# **A G E N D A**

## **Architectural Review Board**

**January 23, 2018**

416 Cloverdale Road

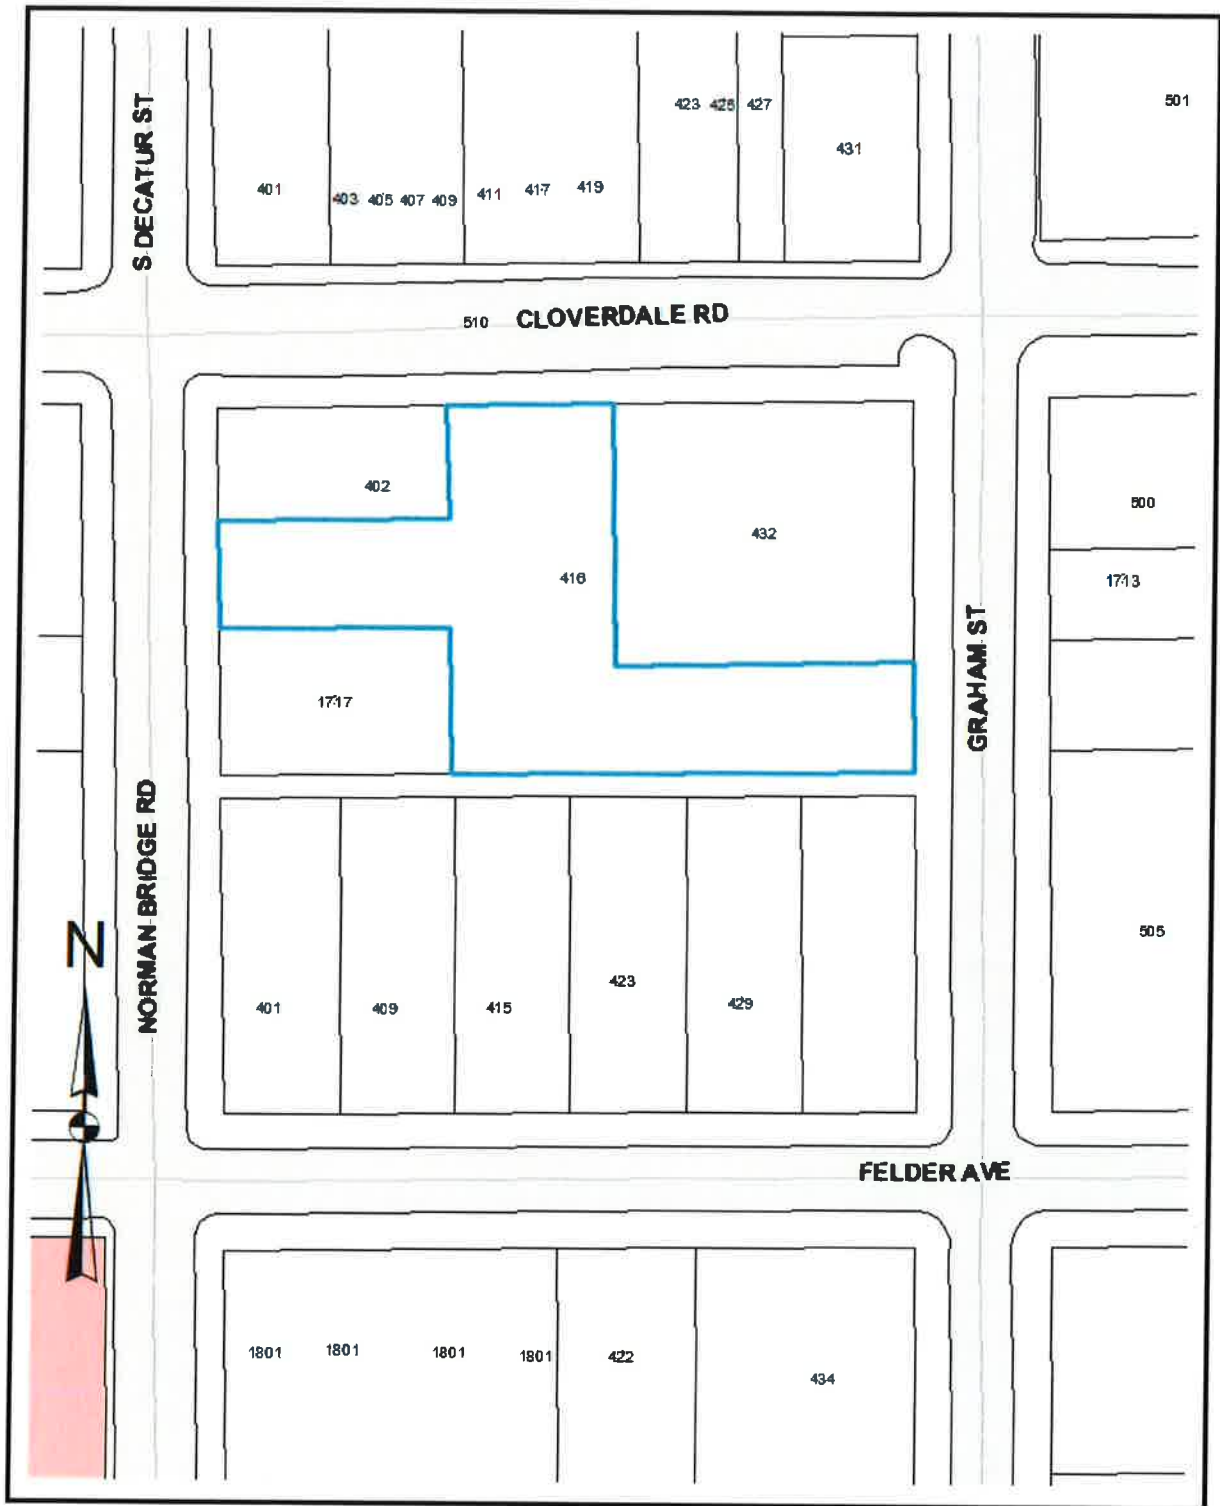
- According to the county tax records, the building was constructed in 1955.
- The Board has generally not approved painting historic brick unless there was a good reason (usually related to structural repairs/highly visible repairs). There is a concern with trapping moisture in older brick, which may not apply in 1955 brick.
- Per the discussion at the November meeting, the paint color for the brick really isn't the primary issue, since the brick could be painted a brick color, and then be painted any color on the palette since it would then be a previously painted surface. The question is whether or not the brick can be painted at all.

1256 South Lawrence Street

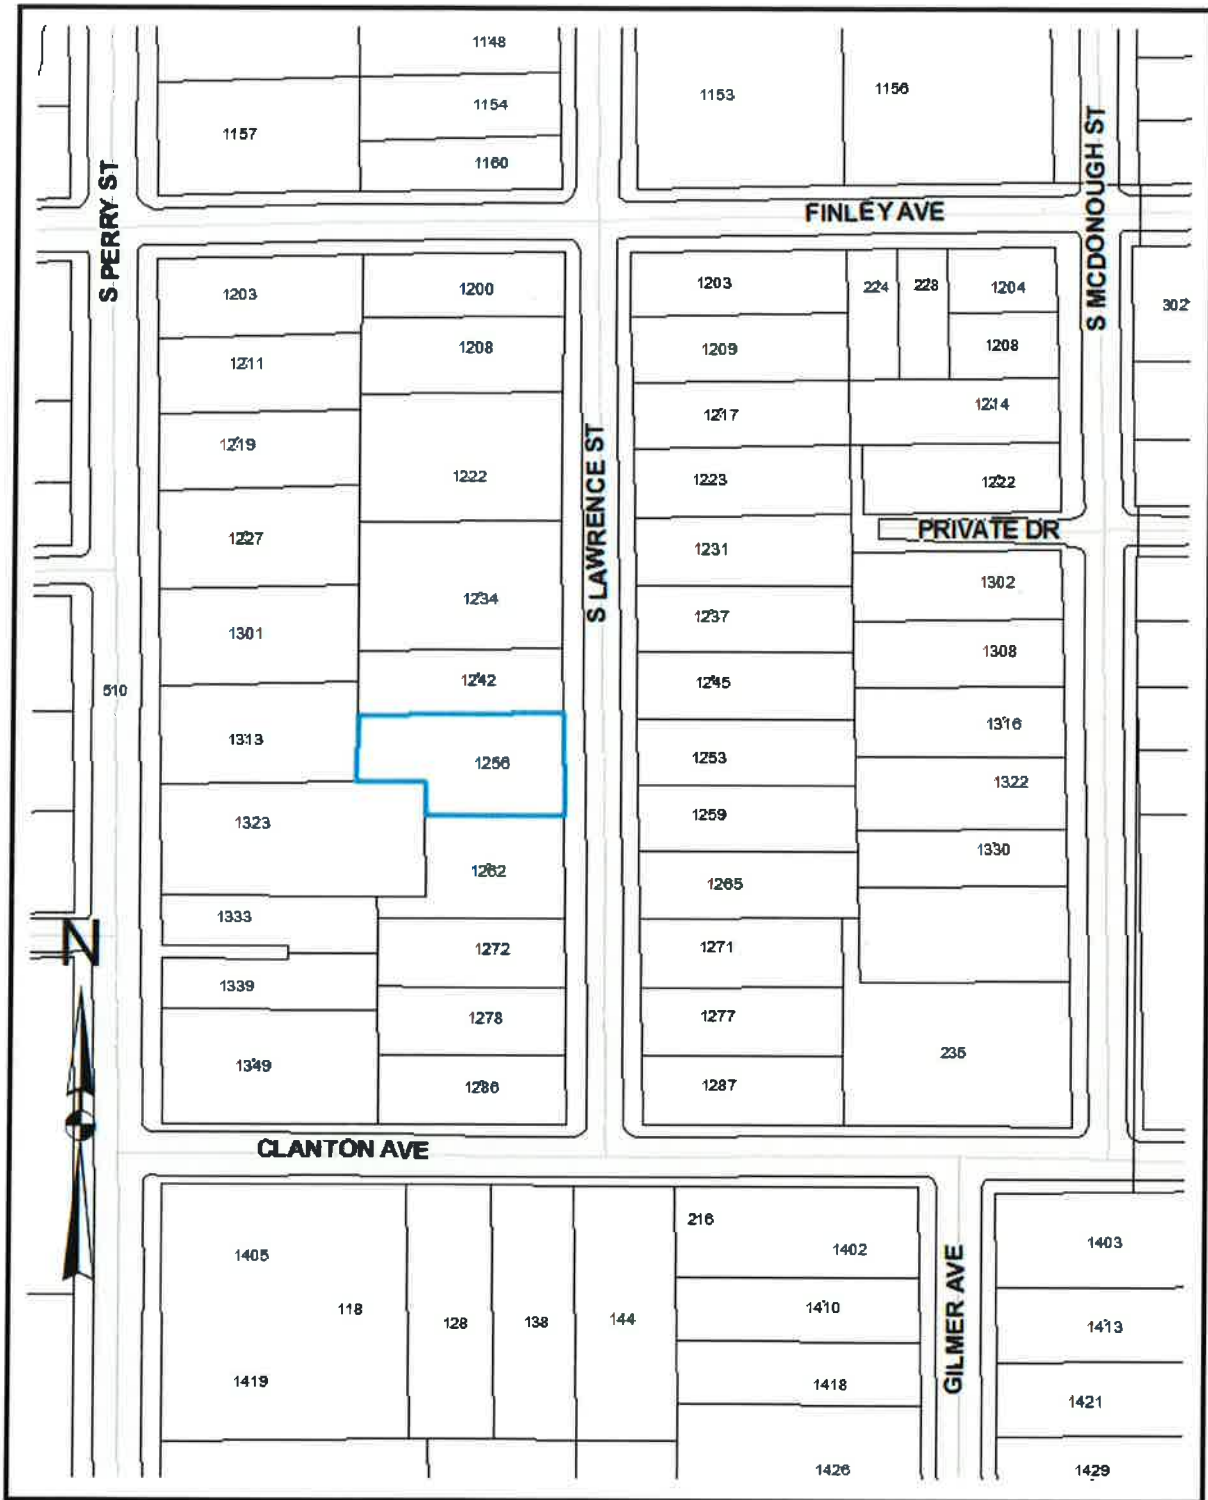
- Proposed replacement should meet city landscape standards (2.5” caliper replacement, no invasive species). No objection to the removal subject to replacement.

ROOF PLAN

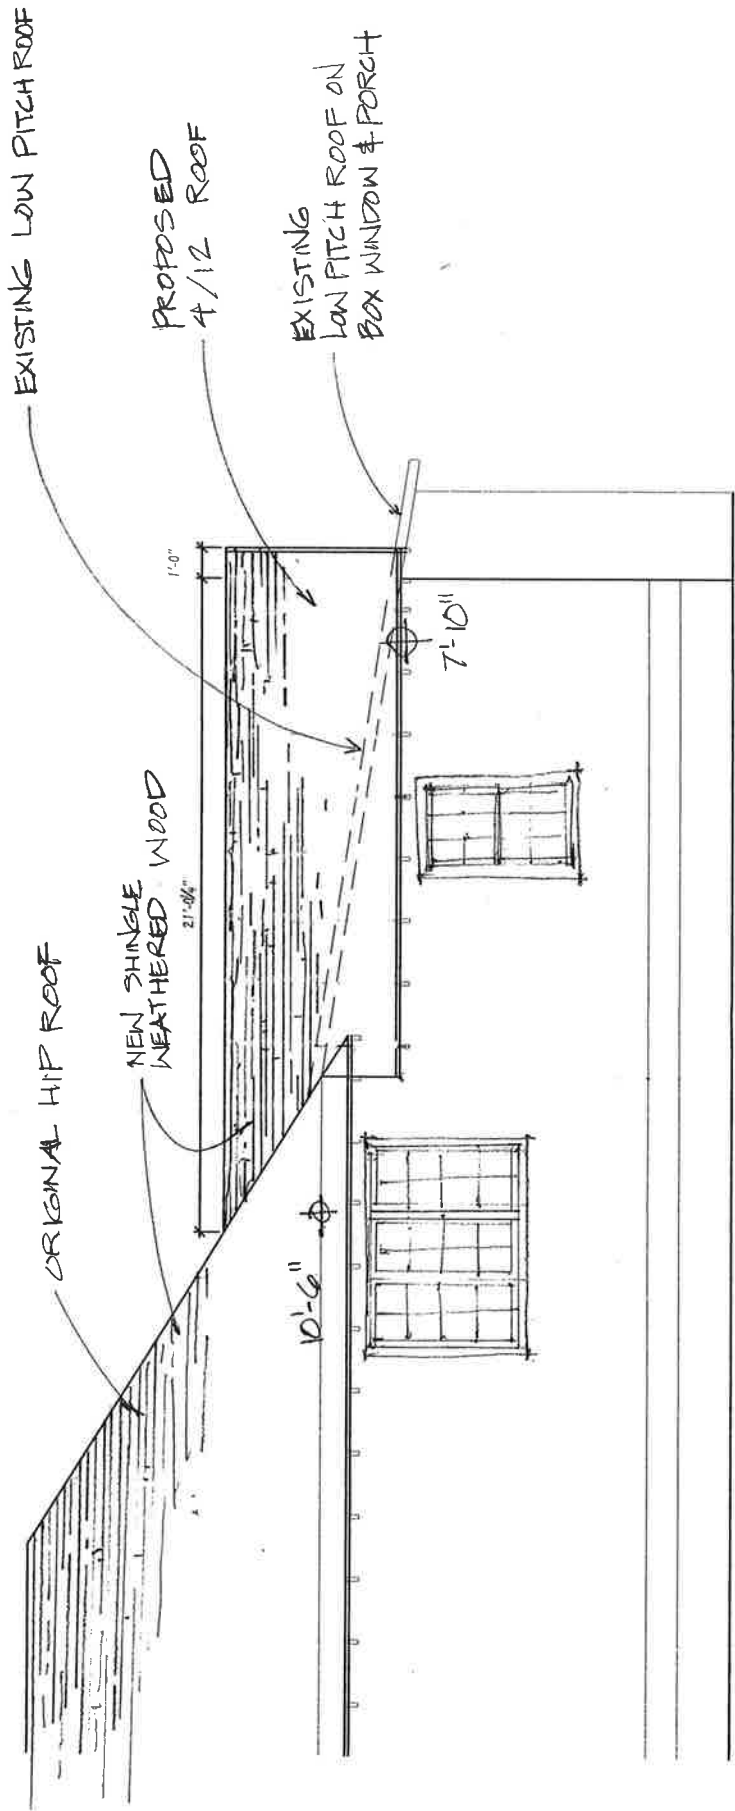
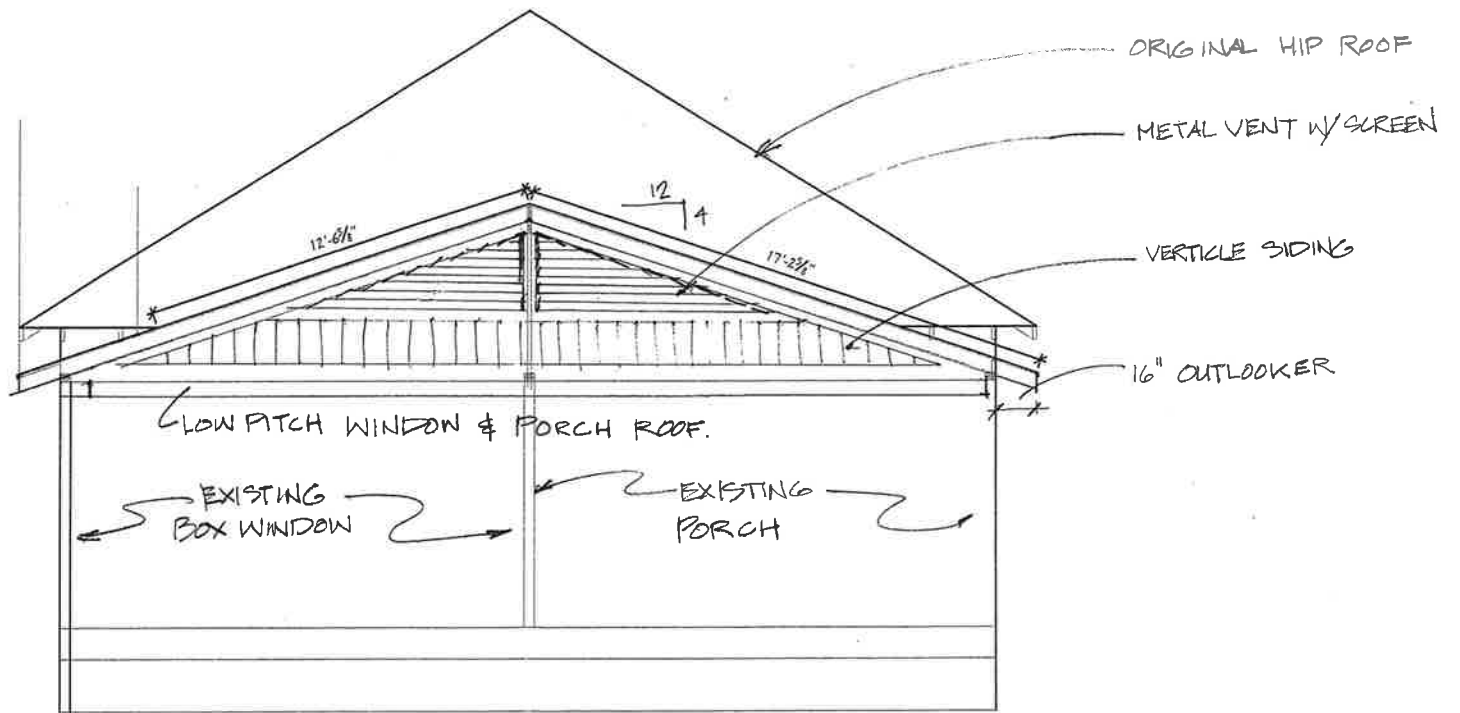
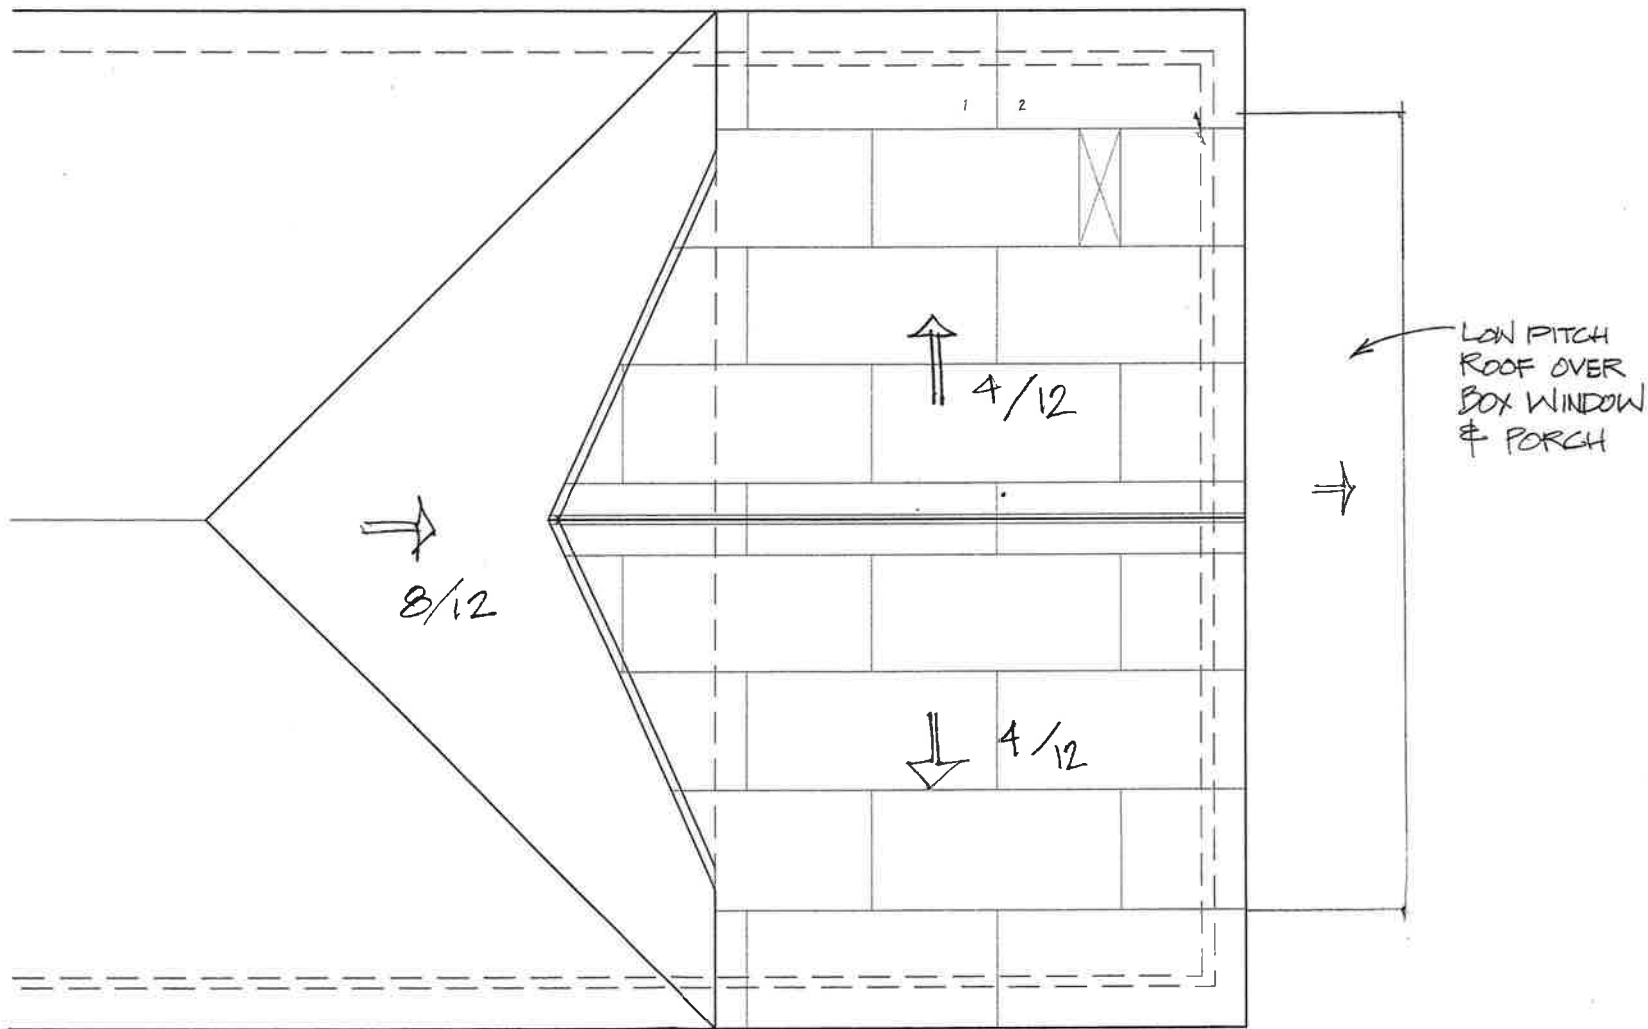
- The alteration is visible from the side street (St. Charles), but the roof pitch will be secondary to the original, historic roof on the main house; distinguishable from the original (as recommended under the Secretary of the Interior’s standards); and address long standing roof leak issues.

805 Cloverdale Road

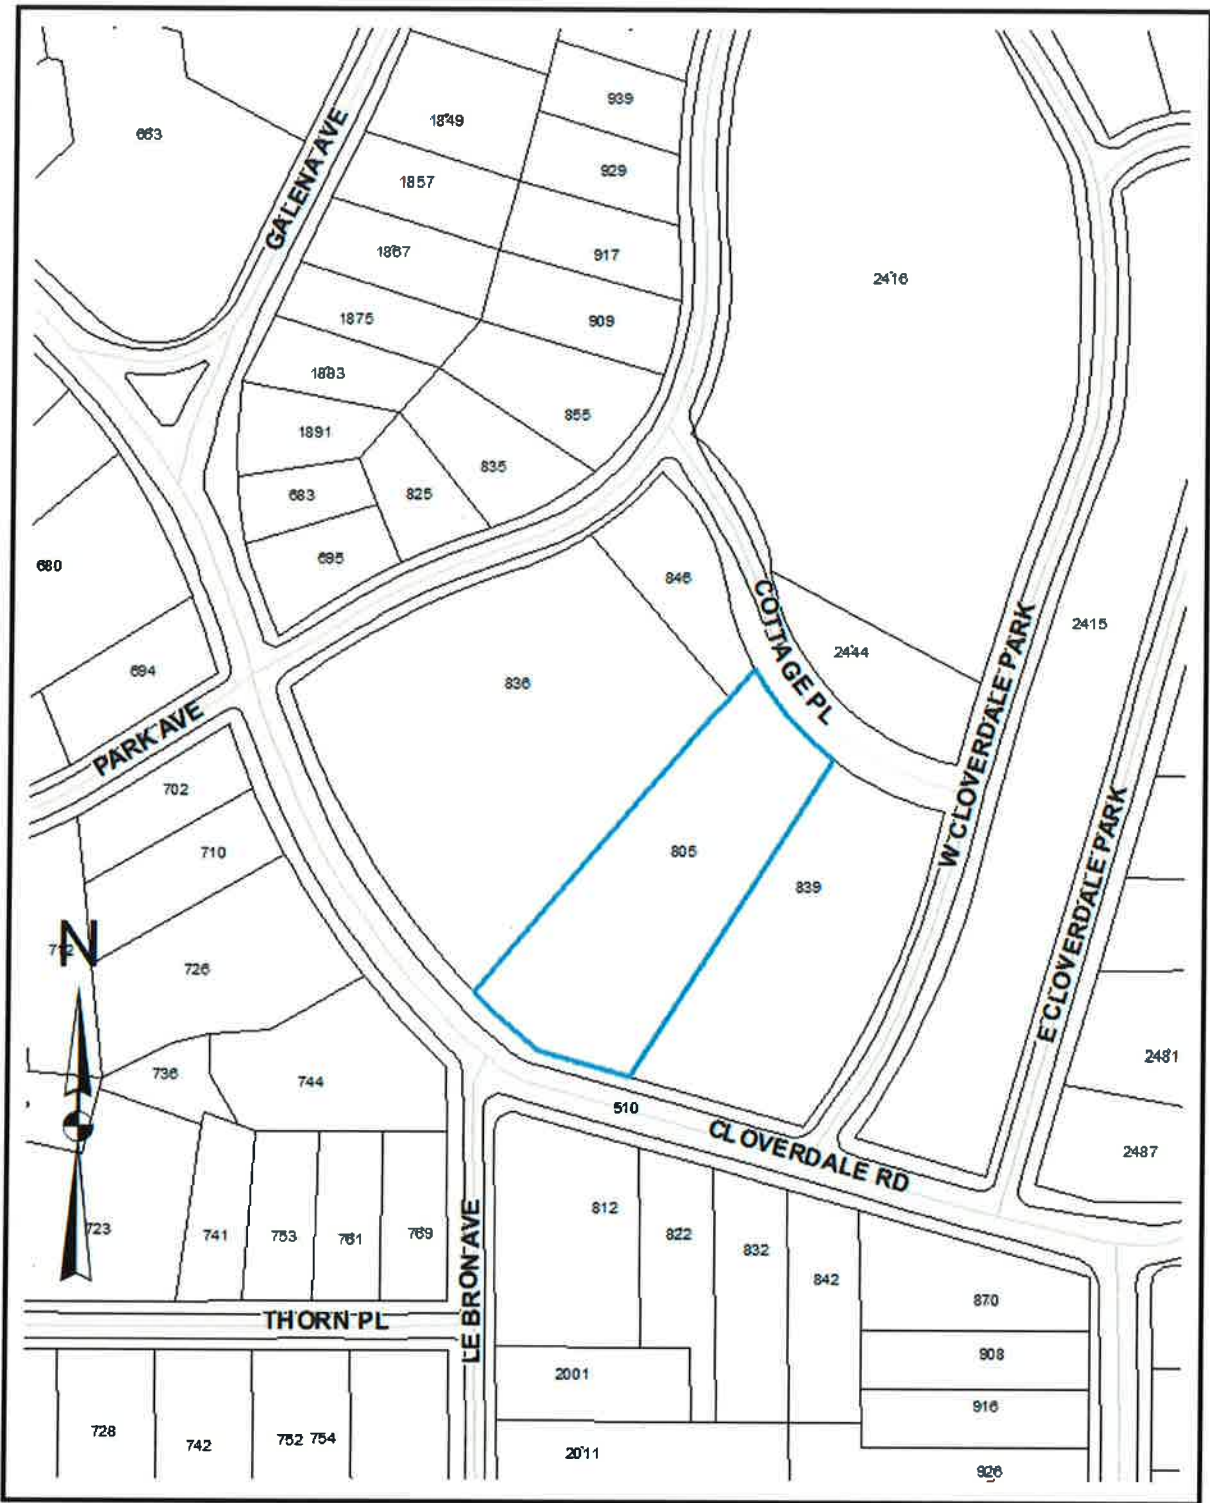
- Hackberry is growing under canopy of tulip poplar and is a "non-contributor".
